Addendum #2 – March 28, 2024

Section 23-08125-02-BR – Prairie Box Culvert Extension

Summary of Changes: Adjusted the depth of the Temporary and Permanent Sheet Piling

**S.N. 053-5533
GENERAL PLAN AND ELEVATION**
SHEET NO. 1 OF 5 SHEETS STA. TO STA.

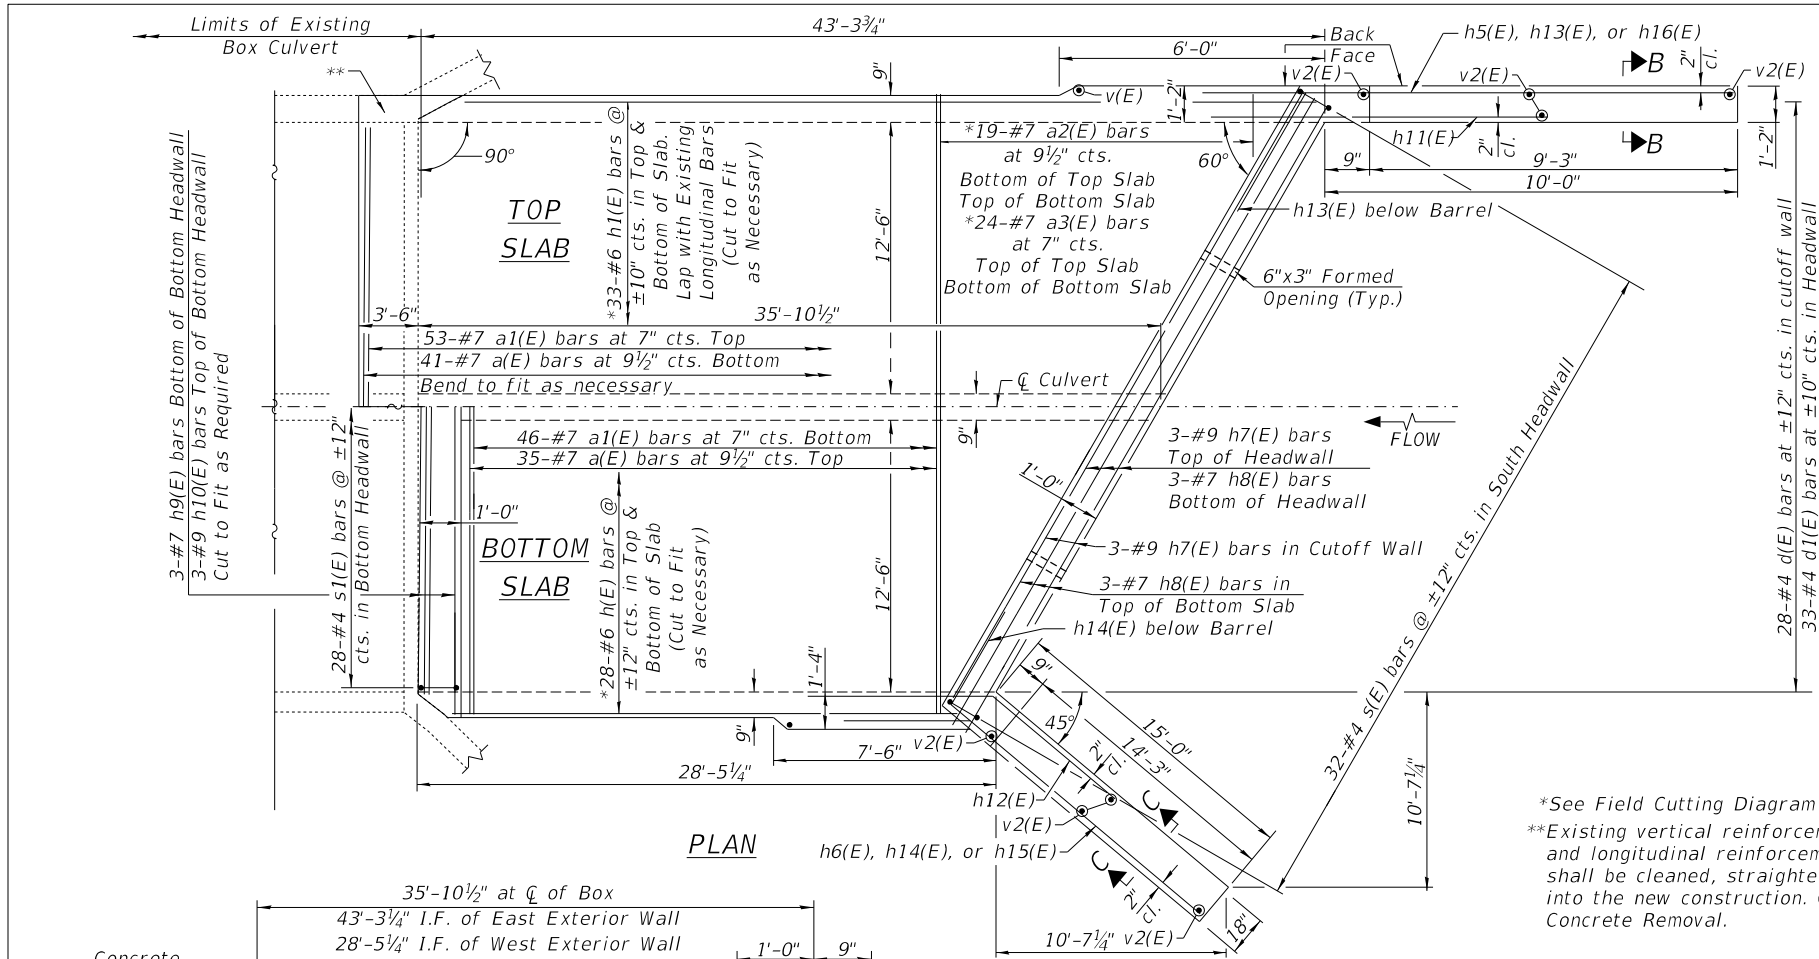
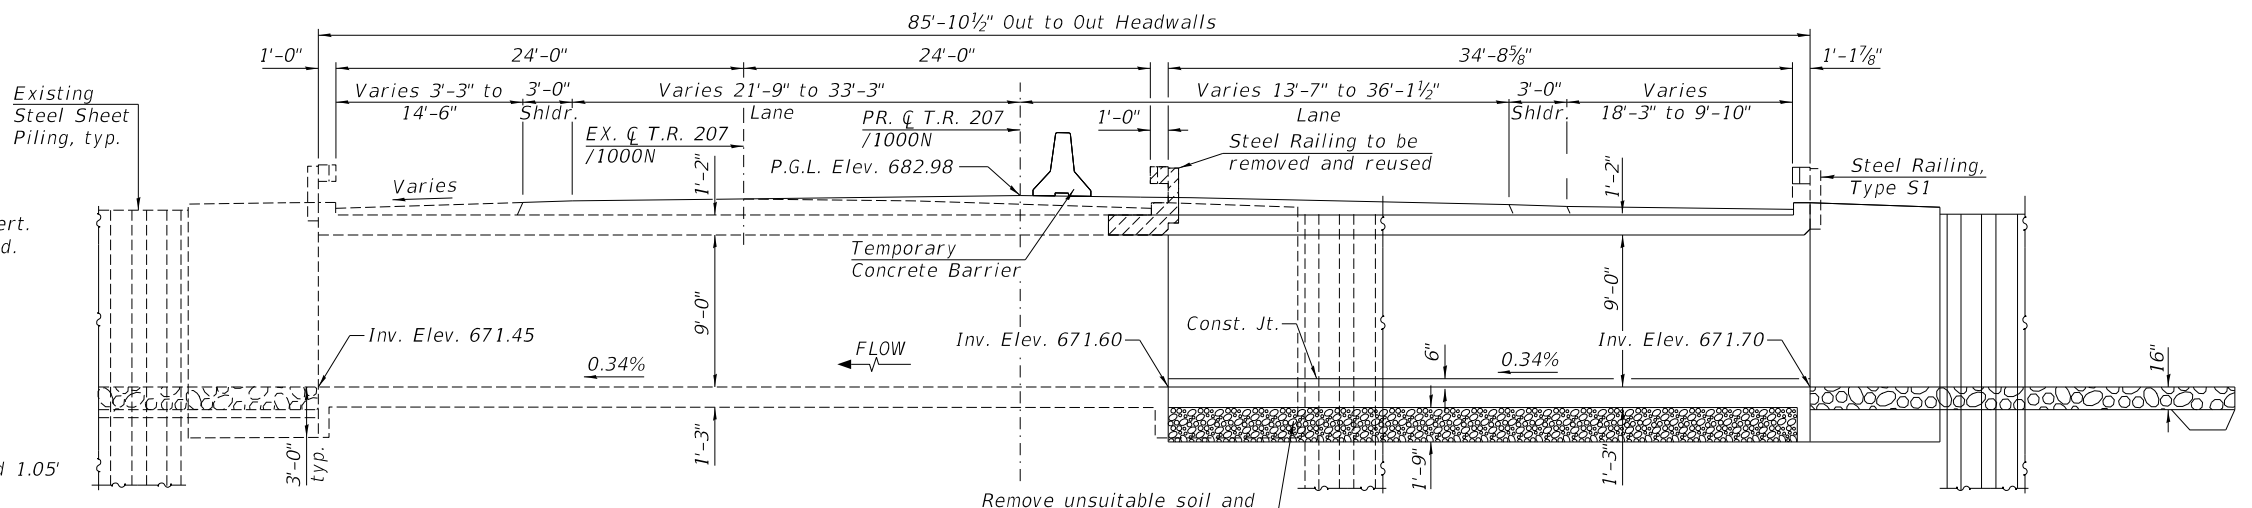
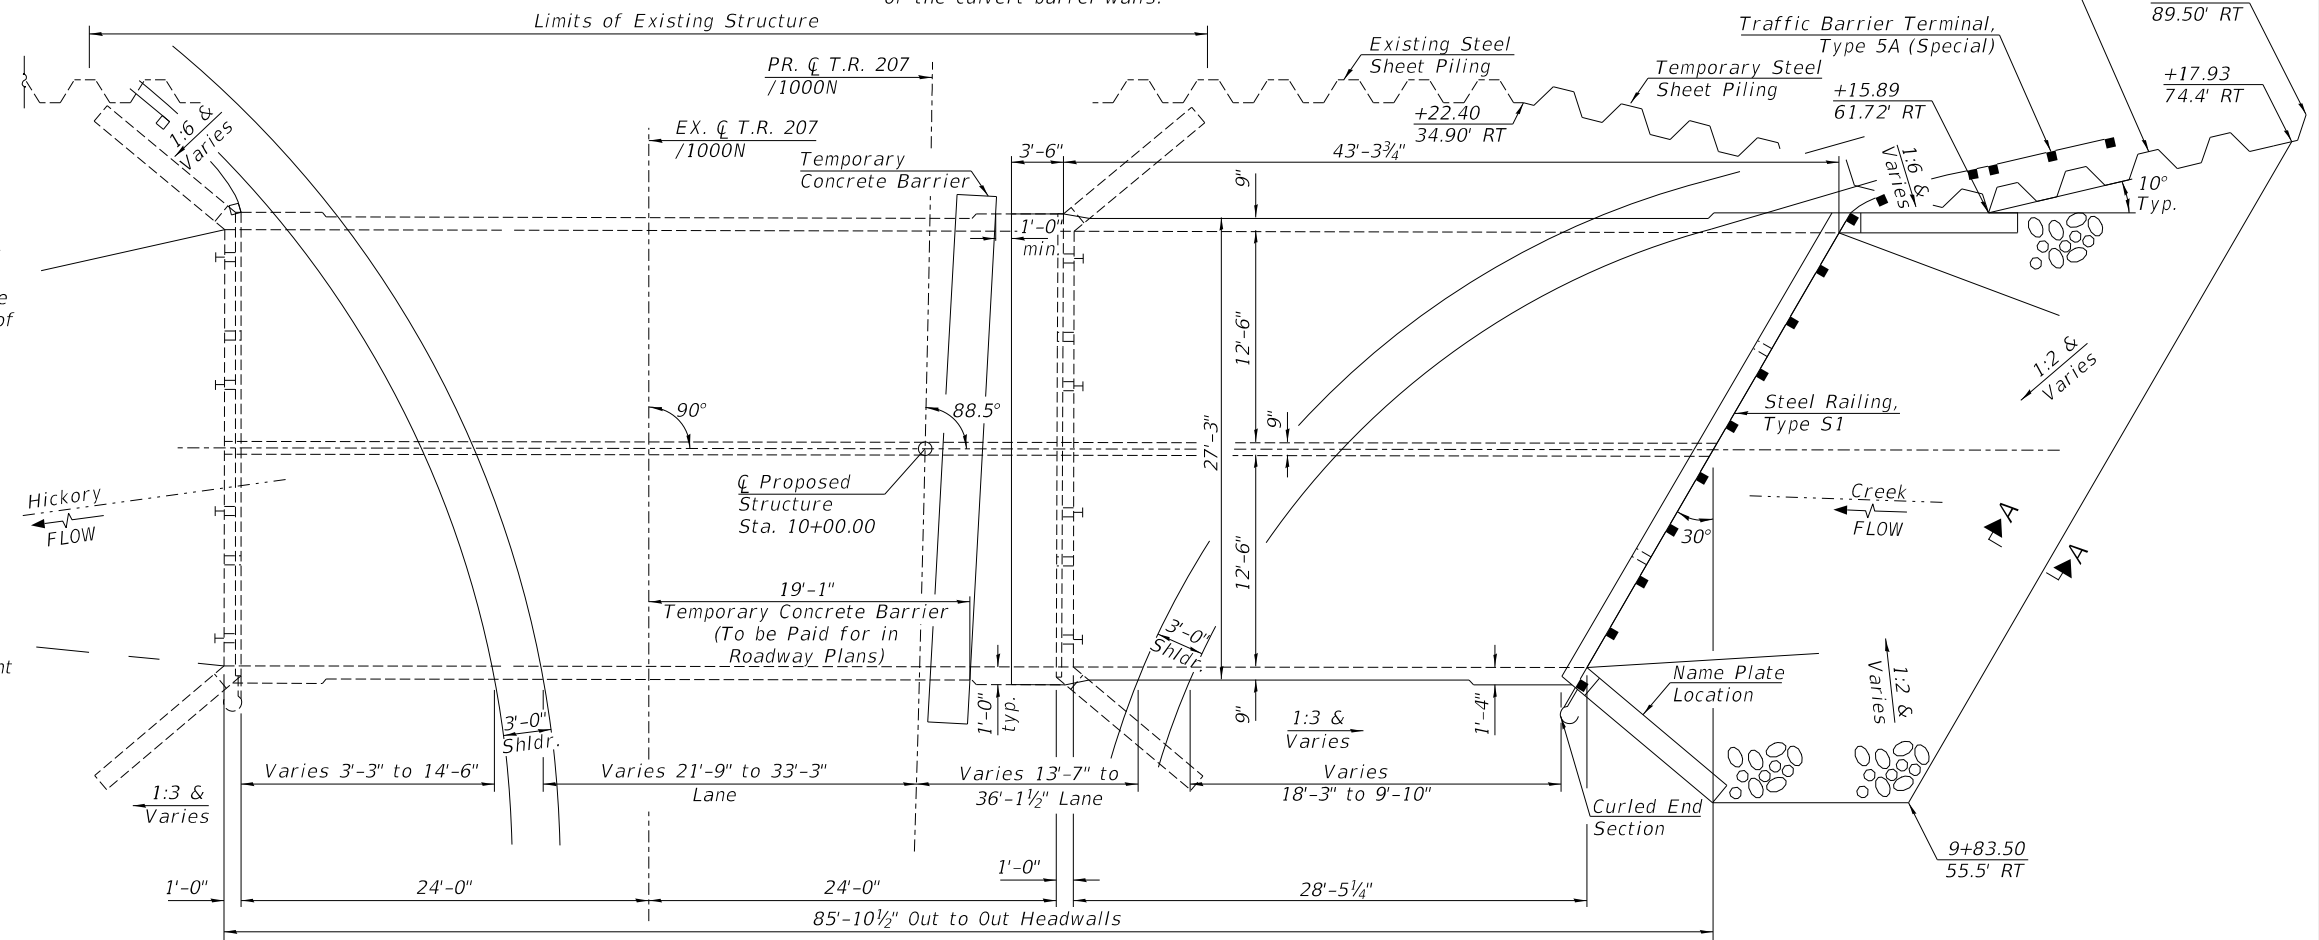
1. Replace Sheet 3 of the Plans with the attached Sheet 3.
2. Replace Sheet 11 of the Plans with the attached Sheet 11.
3. Replace Sheet 13 of the Plans with the attached Sheet 13.
4. Replace the Schedule of Prices on Page 7 of the proposal with the attached Schedule of Prices.
(Note: the electronic Schedule of Prices should be used)

ITEM	UNIT	TOTAL
Removal & Disposal of Unsuitable Material	CU YD	75
Stone Dumped Riprap, Class A4	SQ YD	80
Porous Granular Embankment	CU YD	140
Reinforcement Bars, Epoxy Coated	POUND	28,090
Concrete Box Culverts	CU YD	140.0
Name Plate	EACH	1
Steel Railing, Type S1	FOOT	33
Expansion Bolts 3/4 Inch	EACH	29
Concrete Removal	CU YD	4.1
Permanent Sheet Piling	SQ FT	756
Temporary Sheet Piling	SQ FT	756
